ADDENDUM NO.: 01
PROJECT NAME: Lincoln Park High School Renovation Project
PROJECT NO.: 05085
CONTRACT NO.: C1582
DATE OF ISSUE: April 27, 2017

NOTICE OF CHANGES, MODIFICATIONS, OR CLARIFICATIONS TO CONTRACT DOCUMENTS

NOTES/OPTIONS:
1. FINISH AND OR COLOR AS SELECTED BY ARCHITECT.
2. PROVIDE OPPOSED BLADE DAMPER.

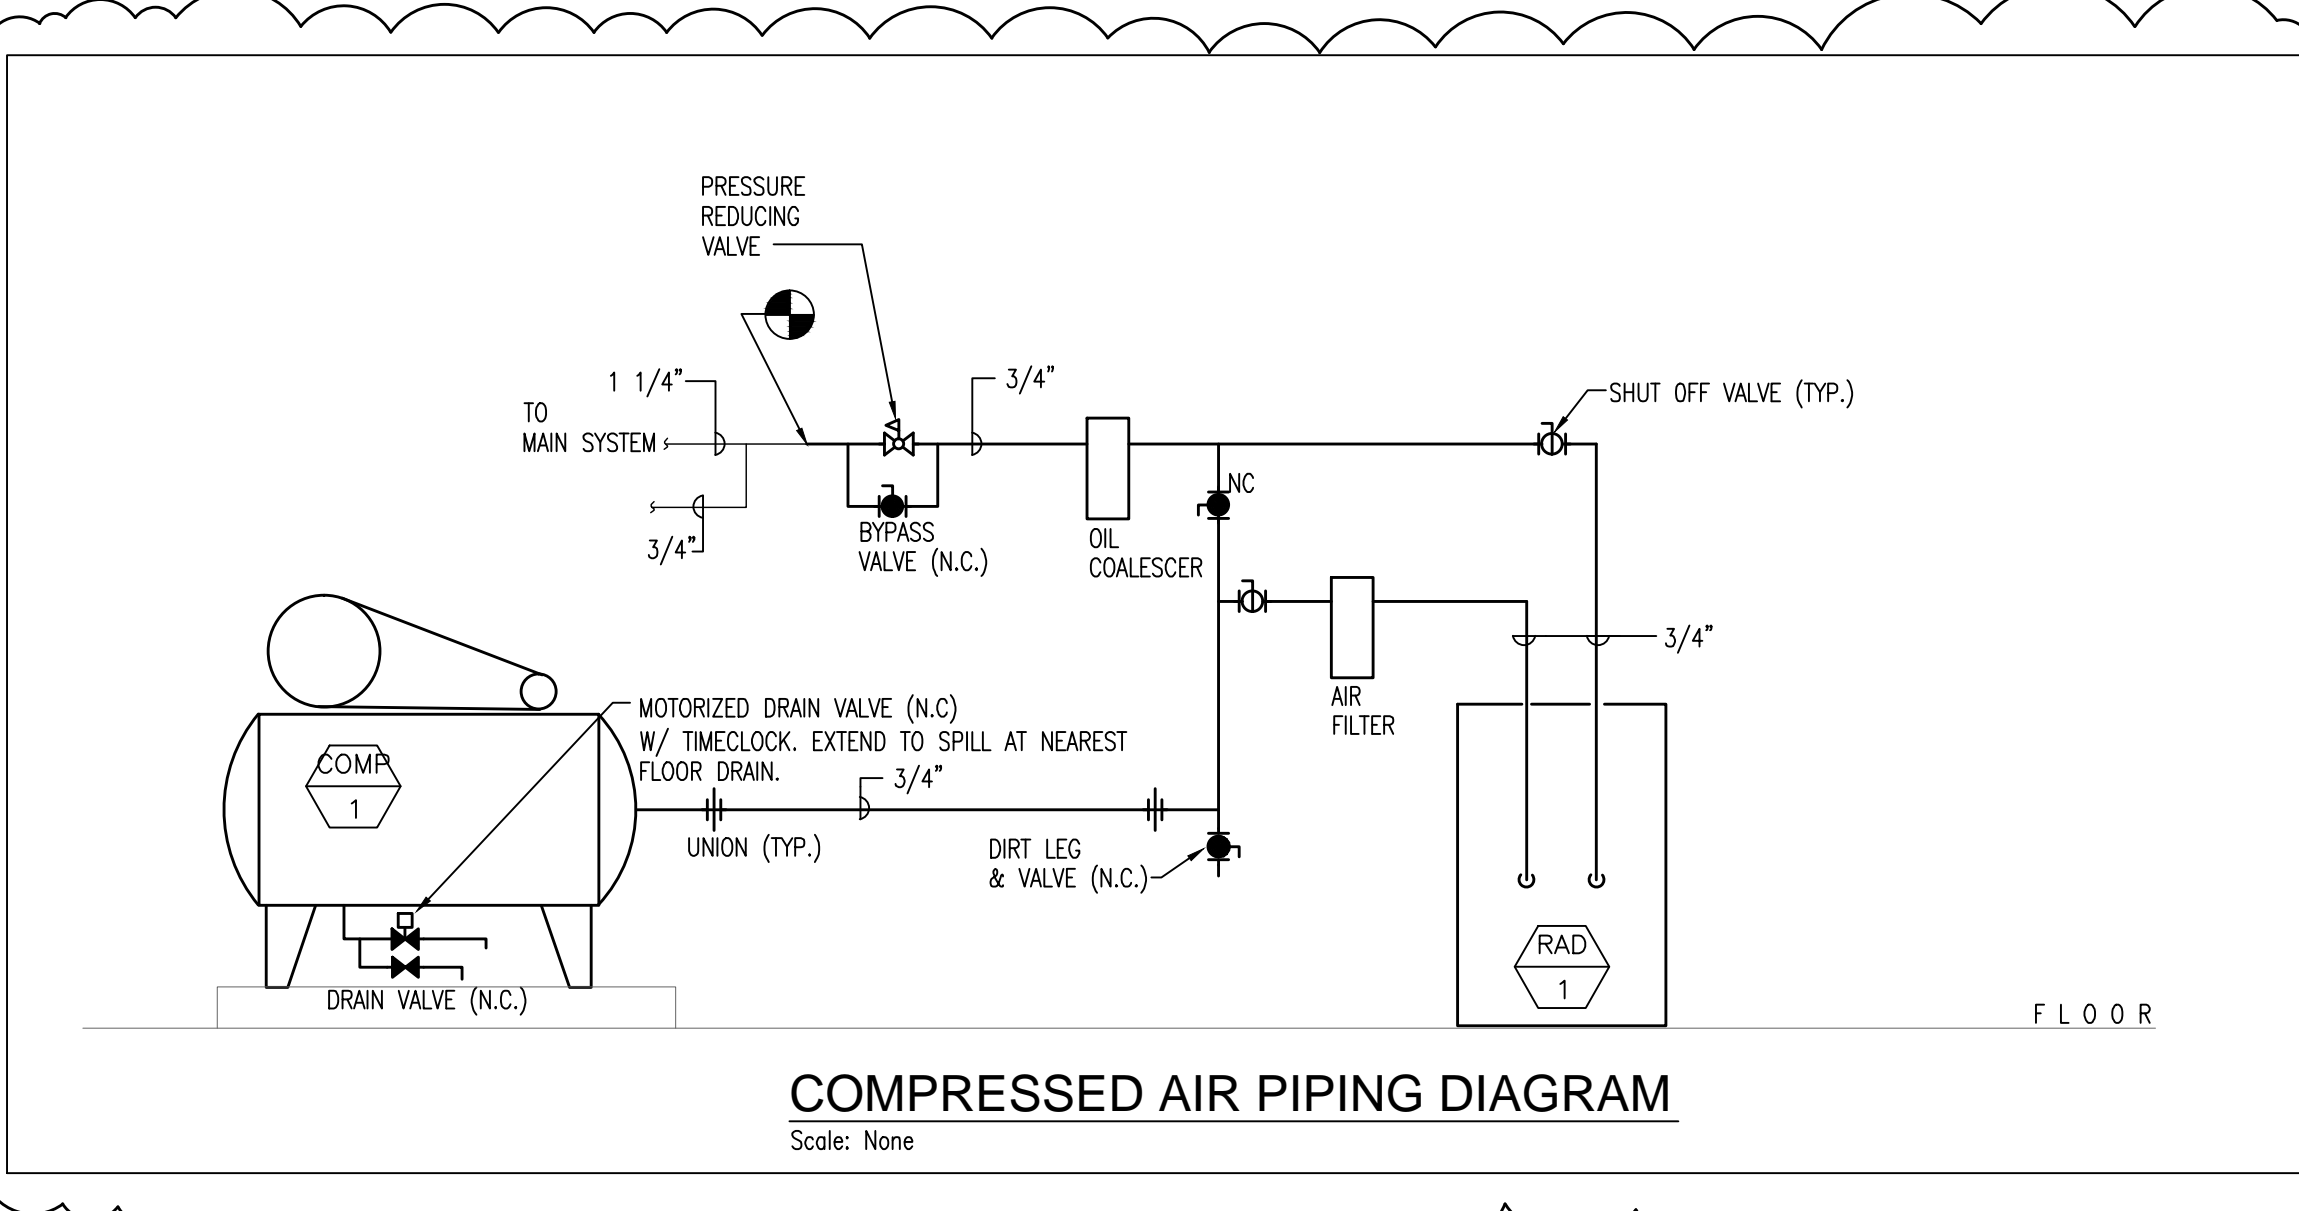
- Change No. 14 Sheet M6.01 ADD: Manufacturer, Model and flow information to Heating Coil Schedule.
- Change No. 15 Sheet M6.02 ADD: Compressed Air Piping Diagram and Piping Diagram for Unit Ventilator.
